# EMPIRE ENGINEERING, PLLC

Empire Engineering, PLLC is in receipt of your Memo received December 15, 2020 regarding the Irwin Indian Fields Road Special Use Permit/Site Plan Review Application. Please find below a response to these comments including any clarification or additional narrative in advance of the January 5, 2021 Planning Board meeting.

Project	<b>Irwin Banquet Facility</b>	Date	<b>December 21, 2020</b>
Location	<b>Indian Fields Road New Scotland, NY</b>	Owner	<b>Jacob Irwin</b>

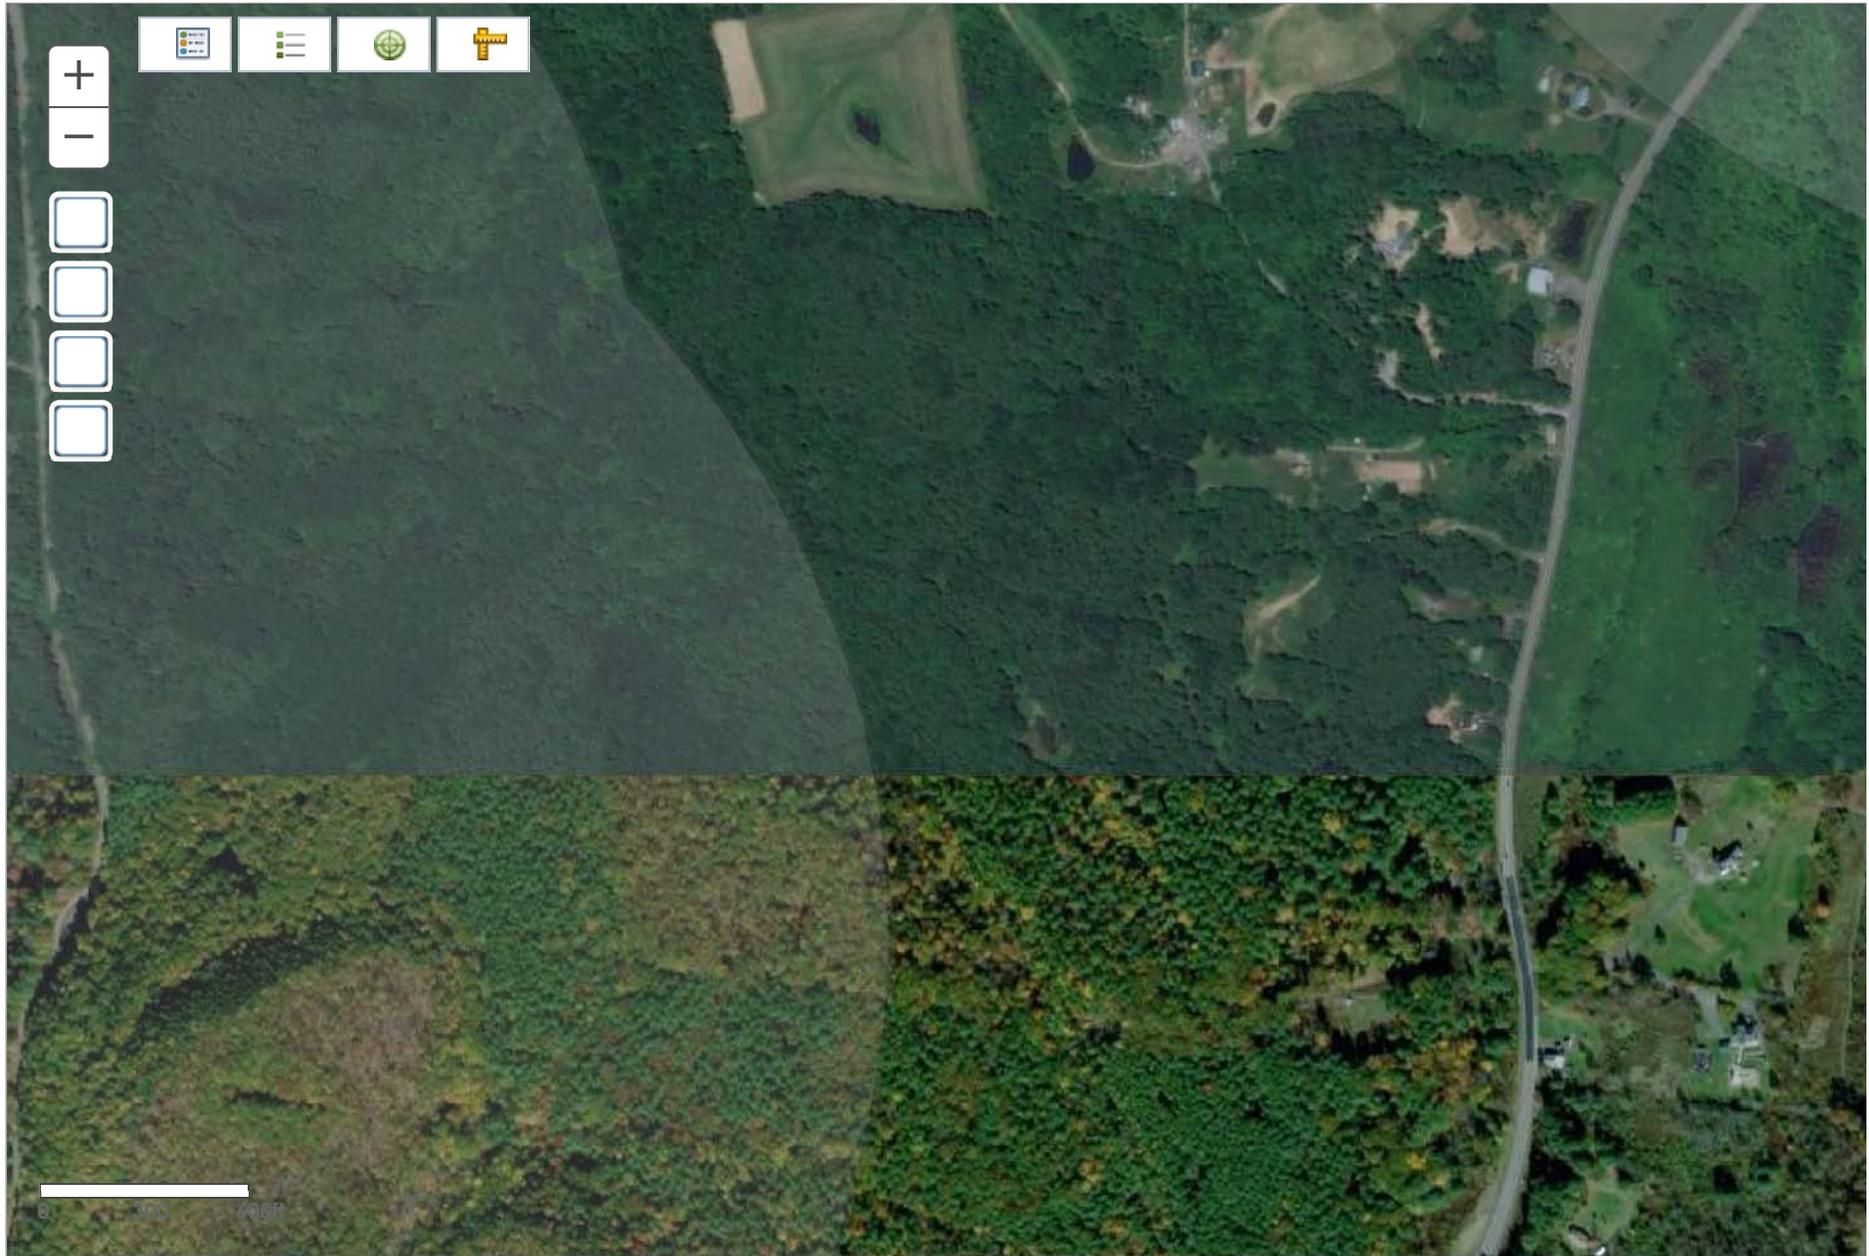
6. This parcel is identified as being in an area having archaeological sensitivity. I suggest that the applicant contact New York State SHPO to review the parcel for archaeological sensitivity. As such, the Planning Board should make sure that it gets correspondence/reports to be kept apprised of any SHPO requirements that may be needed for development of this parcel.

**Attached is a map indicating the archeologically sensitive 'bubbles' near the project site. Although the 'bubble' extends to the parcel, the project site location is not within an archeologically sensitive area. Additional consultation may be conducted if necessary, however, it does not appear to be warranted.**
